CONSTRUCTION SUMMARY

31R - 1 - 25-1 Elev.B RIVERSTONE

LOT
31R
July 28 2016.

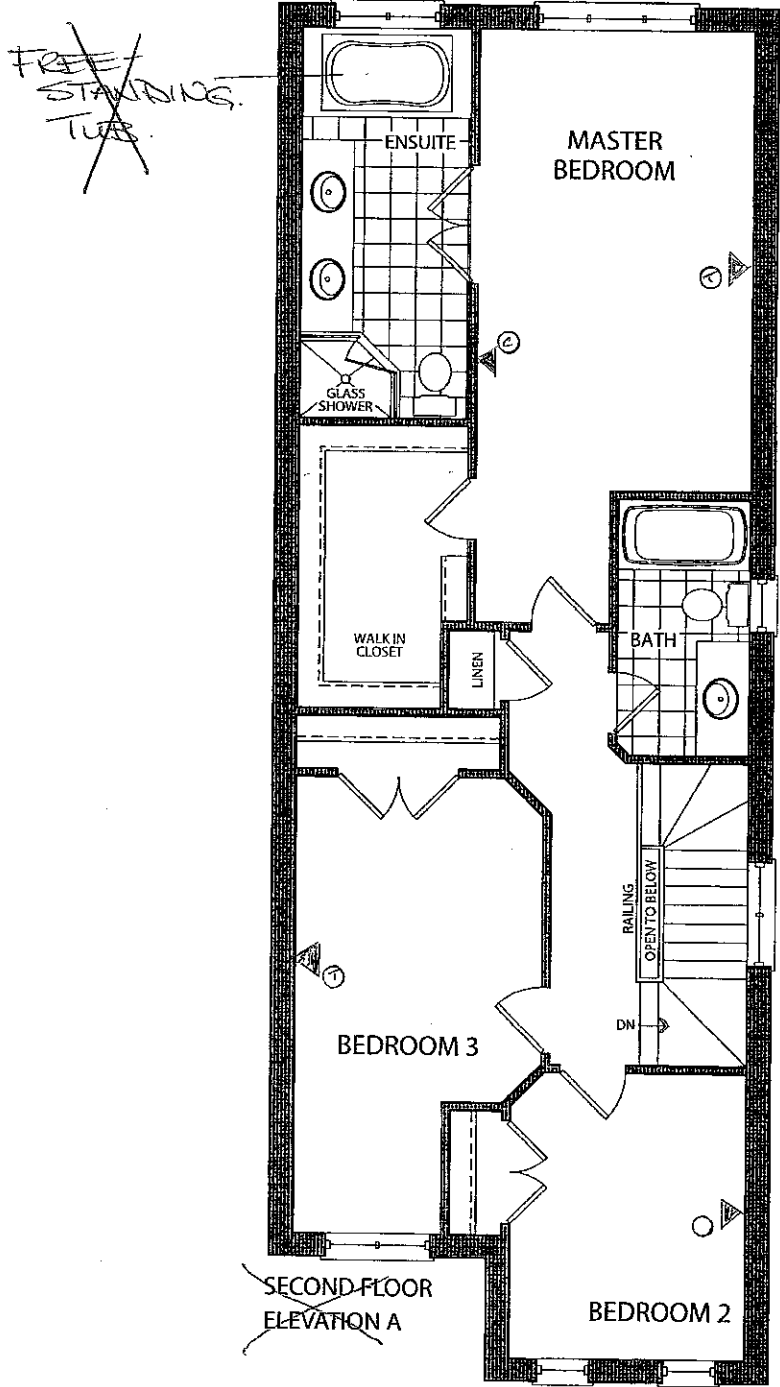
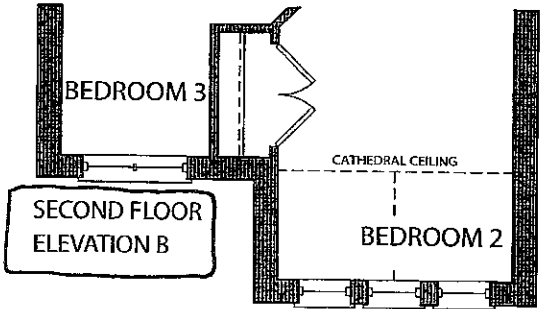
Inv.707	1 - MUD ROOM: ROUGH - IN FOR EXTRA SECURITY KEY PAD
Line9461	Note:
28Jul16 / 17Oct16	
Inv.707	1 - FAMILY ROOM: CONDUIT PIPE - FOR TELEVISION - Locate approx. 60" A.F.F. above fireplace. Terminating left of fireplace by cable outlet. See plan for location.
Line9462	Note:
28Jul16 / 17Oct16

Inv.707	1 - FAMILY ROOM: 110V WALL RECEPTACLE ON NORMAL CIRCUIT -Locate approx. 60" A.F.F. above fireplace for tv. See plan for location.
Line9463	Note:
28Jul16 / 17Oct16	
Inv.707	1 - KITCHEN: RELOCATE STANDARD CEILING to above island. See plan for location.
Line9464	Note:
28Jul16 / 17Oct16	
Inv.707	1 - KITCHEN: ROUGH - IN CEILING OUTLET ON SAME SWITCH - DOES NOT INCLUDE FIXTURE - Locate above island, use same switch as standard light. See plan for location.
Line9465	Note:
28Jul16 / 17Oct16	
Inv.707	1 - KITCHEN: 110V WALL RECEPTACLE ON DEDICATED CIRCUIT - FOR MICROWAVE - MICROWAVE & cabinetry customization NOT INCLUDED. See plan for location.
Line9466	Note:
28Jul16 / 17Oct16	
Inv.707	1 - KITCHEN: 220V WALL RECEPTICAL ON DEDICATED CIRCUIT - FOR 4 WIRE BUILT - IN WALL OVEN - See plan for location.
Line9467	Note:
28Jul16 / 17Oct16	
Inv.707	1 - KITCHEN: RE-CENTER future cooktop in space, see plan for location.

STRUCTURAL-2.

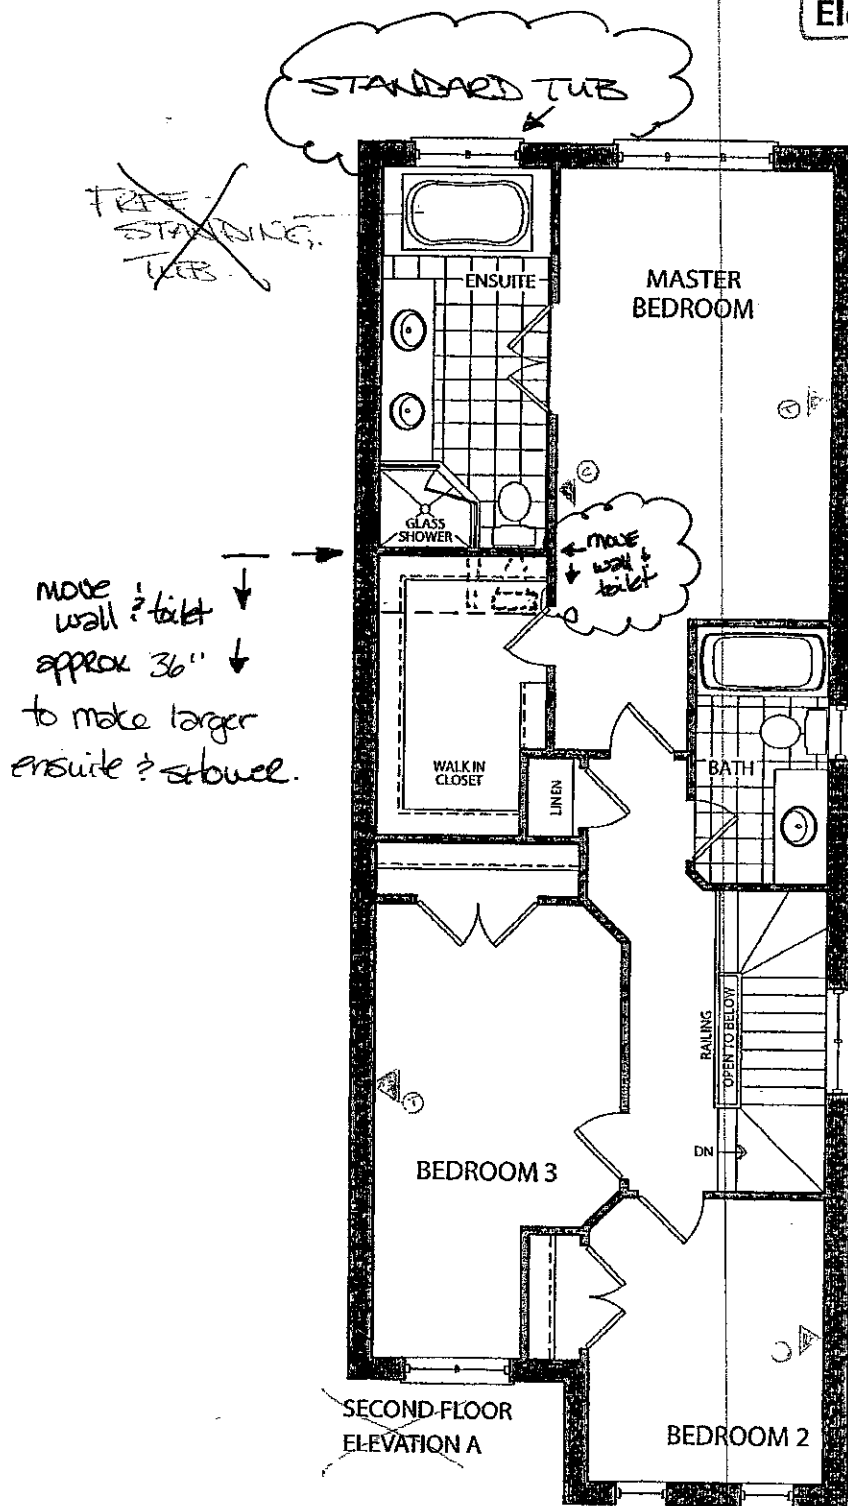
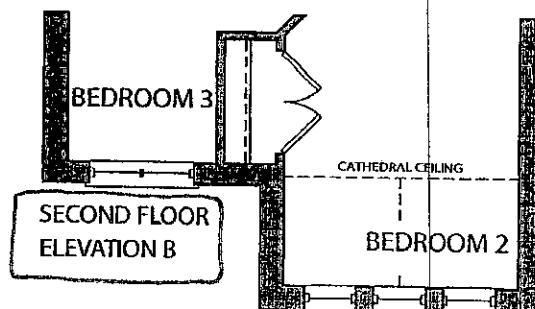
Inv.707	2 - MAIN FLOOR: FRAME MAIN FLOOR ARCHES AT 96 INCH
Line9472	Note:
28Jul16 / 17Oct16	
Inv.785	5 - MAIN FLOOR: FRAME MAIN FLOOR DOORS AT 96 INCH - ADDED WITH THE ADDITION OF TALLER INTERIOR DOORS (not including door from house to garage or front door) See plan for location.
Line10545	Note:
25Aug16 / 17Oct16

Inv.707	2 - MAIN FLOOR: EXTENDED HEIGHT ARCHWAY-96" (PRICE PER DOORWAY)
Line9473	Note:
28Jul16 / 17Oct16	
Inv.785	5 - MAIN FLOOR: STANDARD DOOR EXTENDED HEIGHT 96 INCH (PRICE PER DOOR) MAIN FLOOR 3 STOREY MODELS - Interior doors - not including door from house to garage or front door) See plan for location.
Line10546	Note:
25Aug16 / 17Oct16

96" interior
doors +
ARCH

STRUCTURAL-2
LOT 31-R
AUGUST 29 2016
[Signature]

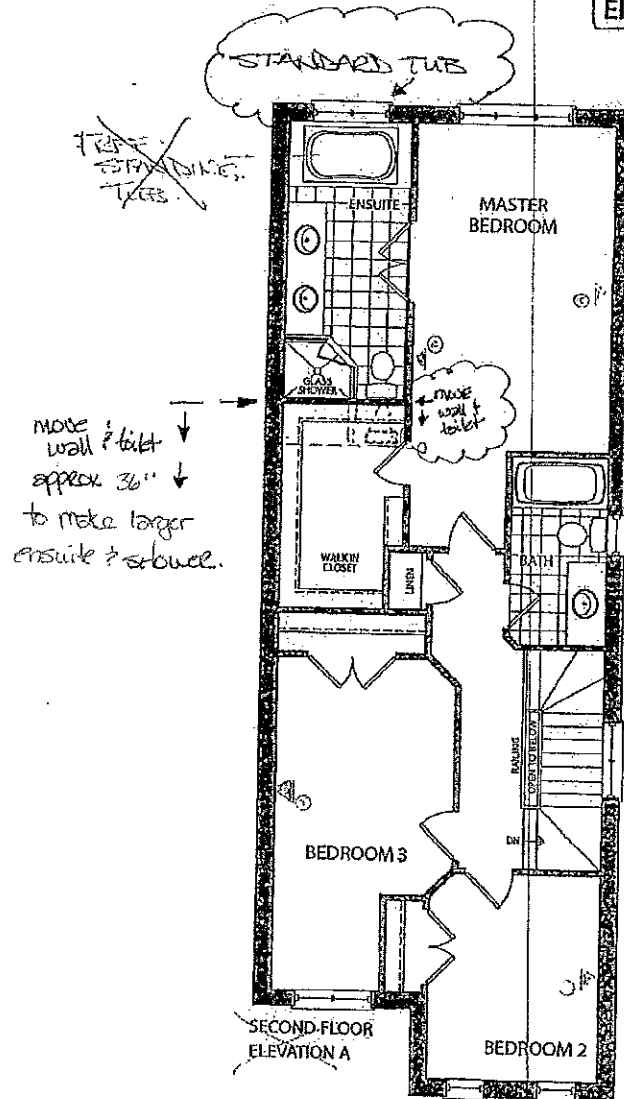
25Aug16 / 17Oct16	
Inv.785	1 - Purchasers are aware & accepts that ANY changes made to upgrades after signing this Purchasers Extra Form are subject to a minimum administration fee of \$500. PLUS a 10% holdback fee.
Line10548	Note:
25Aug16 / 17Oct16	
Inv.785	1 - MASTER ENSUITE: **REVISED LAYOUT** Move wall between Master Ensuite/ WIC approx. 36" making closet smaller and bathroom larger. See plan for location.
Line10547	Note:
25Aug16 / 17Oct16
